STAFF REPORT
(ONE-STEP FINAL PLAT)

CASE NUMBER: SUB 2002-63 -- SPENCER'S FIRST ADDITION

STAFF REPORT
(One-Step Final Plat, Deferred 7/18/02)

RE: Drainage Concept
Spencer's First Addition

SITE PLAN

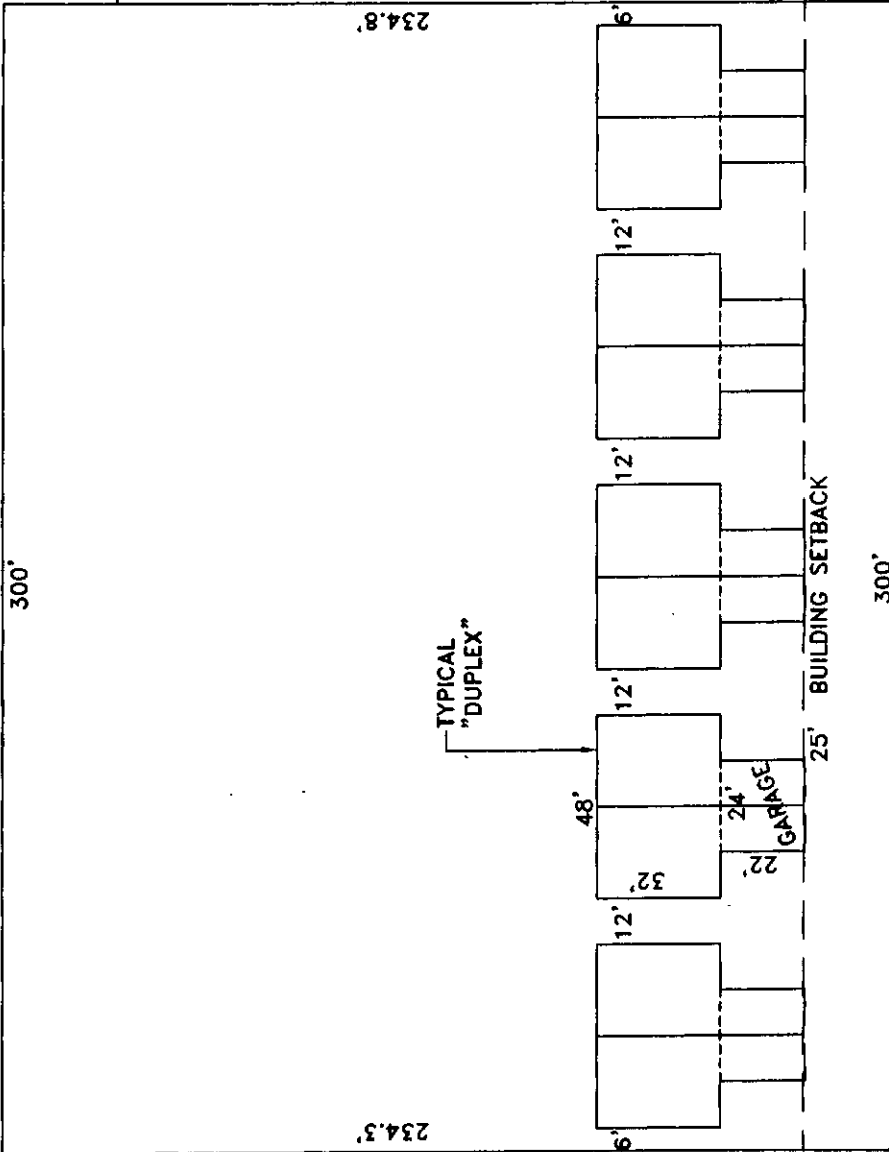
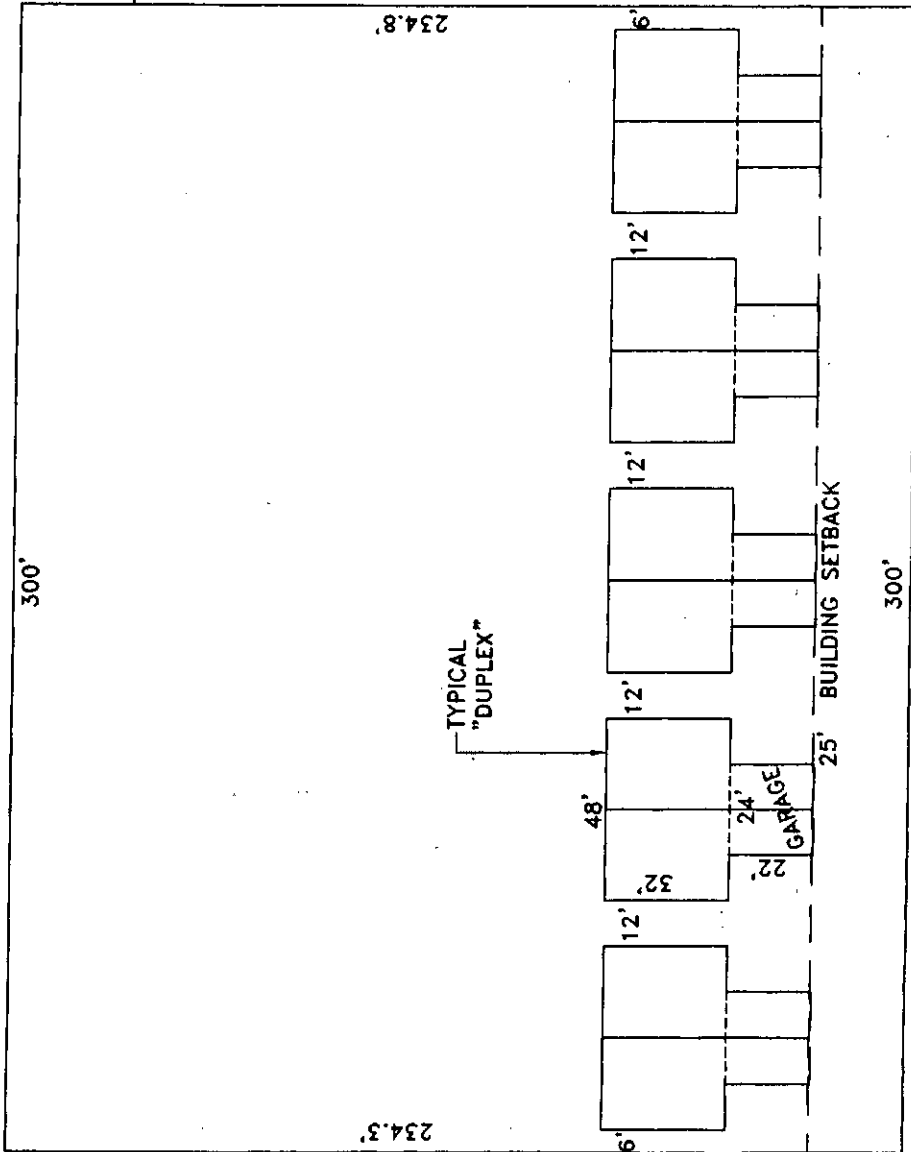
- G. As a lot used for multi-family uses adjacent to non-arterial streets, the Subdivision regulations require a sidewalk along St. Louis and Hoover.
- H. The setback denoted on the site plan does not correspond with the setback denoted on the plat.

- F. As a lot used for multi-family uses adjacent to non-arterial streets, the Subdivision regulations require a sidewalk along St. Louis and Hoover.
- G. The applicant has platted a 6-ft street side setback along St. Louis, in lieu of the required 15 feet. The Subdivision Regulations permit the setback provisions to be modified by the plat upon the approval of the Planning Commission.
